<b>Title - Sujet</b> PERIMETER DETECTION SYSTEMS CCTV		
<b>Solicitation No. - N° de l'invitation</b> 21120-147874/A		<b>Amendment No. - N° modif.</b> 007
<b>Client Reference No. - N° de référence du client</b> 21120-14-2007874		<b>Date</b> 2014-08-14
<b>GETS Reference No. - N° de référence de SEAG</b> PW-\$\$HN-334-64960		
<b>File No. - N° de dossier</b> hn334.21120-147874	<b>CCC No./N° CCC - FMS No./N° VME</b>	
<b>Solicitation Closes - L'invitation prend fin</b> <b>at - à 02:00 PM</b> <b>on - le 2014-09-05</b>		<b>Time Zone</b> <b>Fuseau horaire</b> Eastern Standard Time EST
<b>F.O.B. - F.A.B.</b> <b>Plant-Usine:</b> <input type="checkbox"/> <b>Destination:</b> <input checked="" type="checkbox"/> <b>Other-Autre:</b> <input type="checkbox"/>		
<b>Address Enquiries to: - Adresser toutes questions à:</b> McLaughlin, Michael		<b>Buyer Id - Id de l'acheteur</b> hn334
<b>Telephone No. - N° de téléphone</b> (819) 956-3622 ( )		<b>FAX No. - N° de FAX</b> ( ) -

**PWGSC File # 21120-147874**  
***Replacement of Perimeter Cameras***  
***For Use in Federal Correctional Institutions***

EMPLACEMENT DES CAMÉRAS  
DE SURVEILLANCE AU CFF

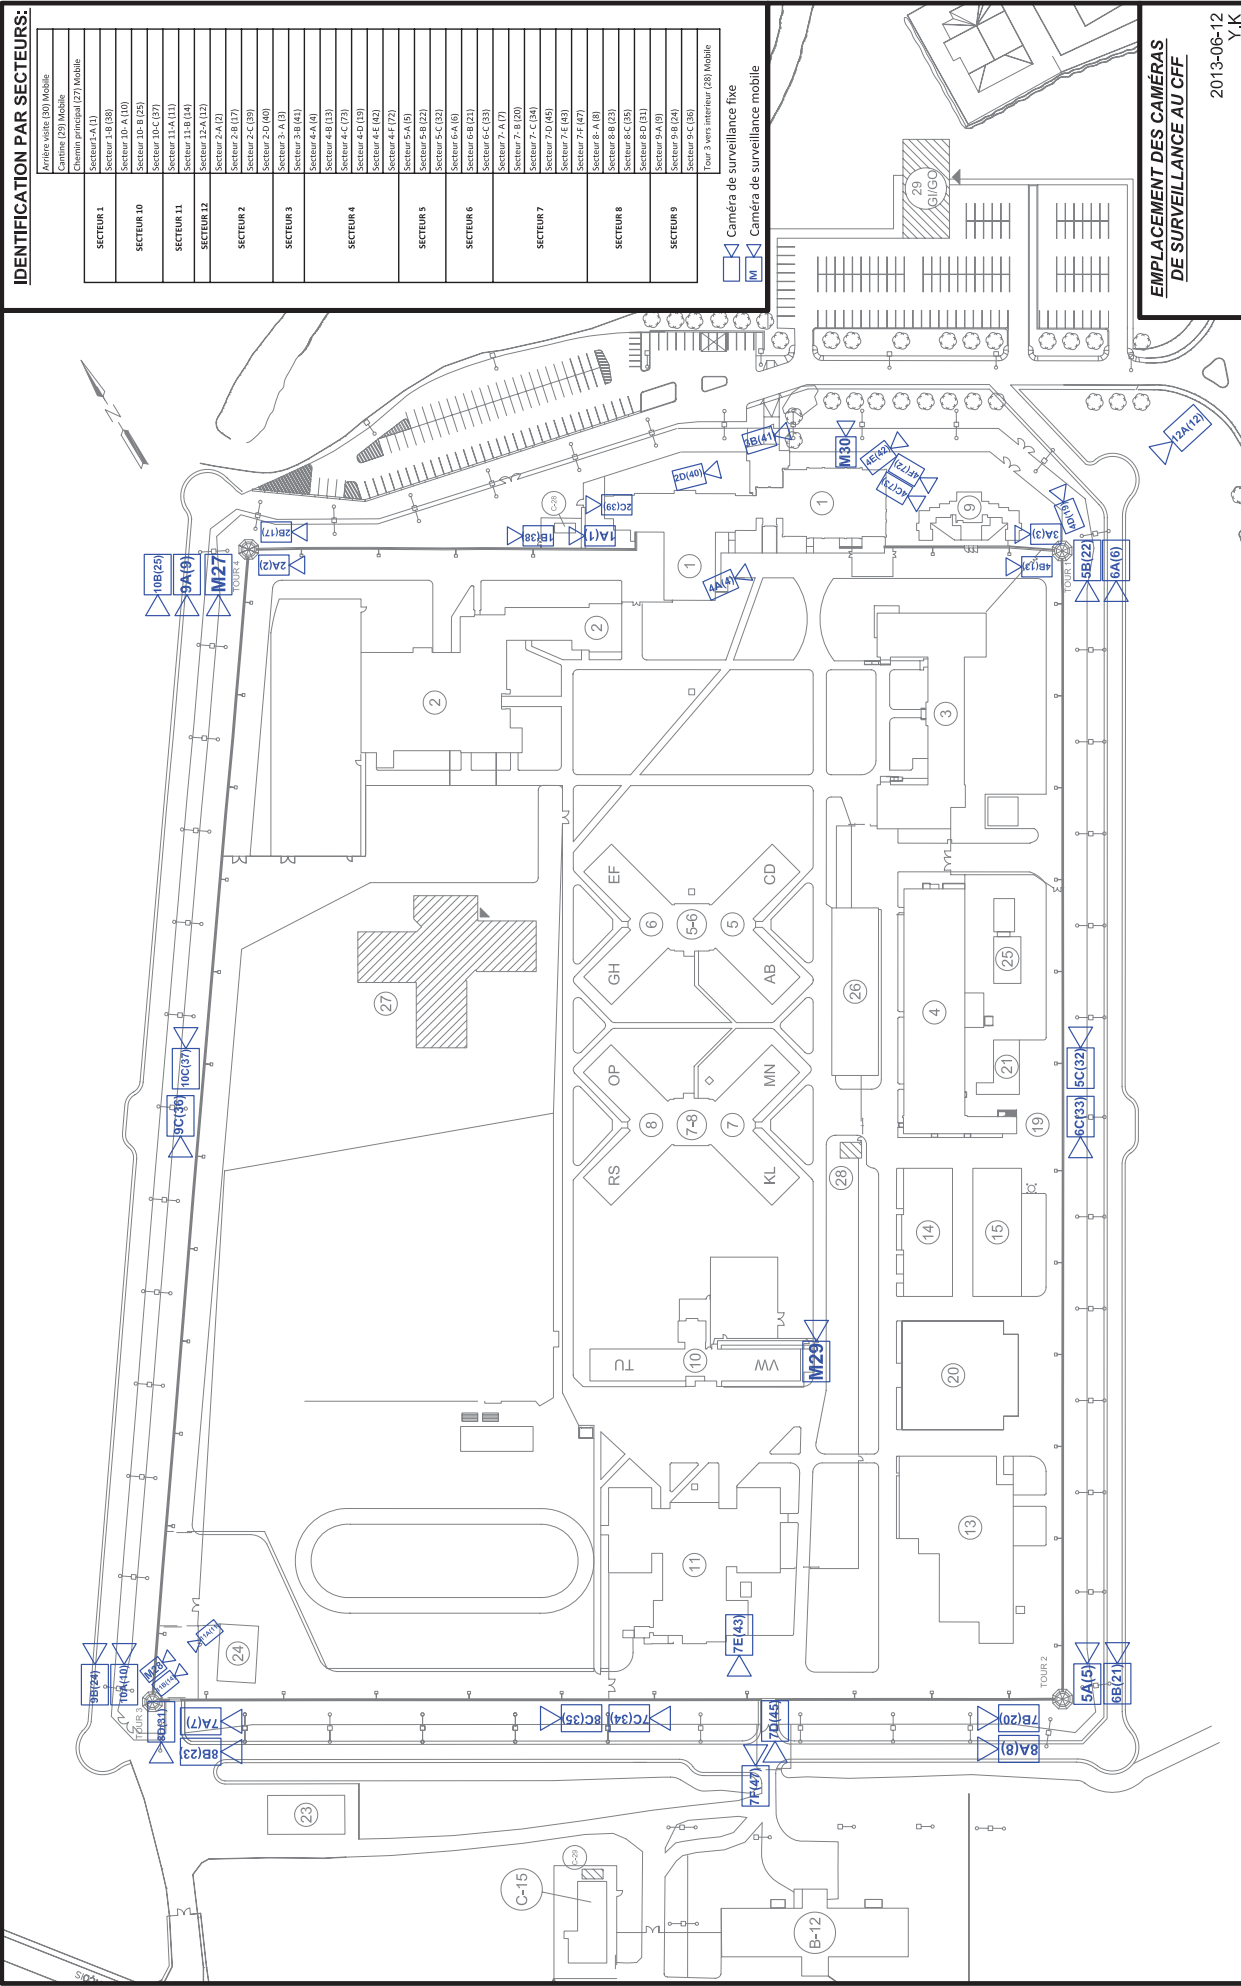
22	Clarifications to section 6.2: It is mentioned that there are 3 cameras on building F, the provided drawings only show 2. Can CSC confirm the location of the missing camera?	A.2.22 See A.2.21  Refer to attached drawing, 3 cameras are on building F.
23	Clarifications to section 6.4: Given the fact that the Edge switches will be	A.2.23 For the site FTC with the new switch infrastructure – the goal is for
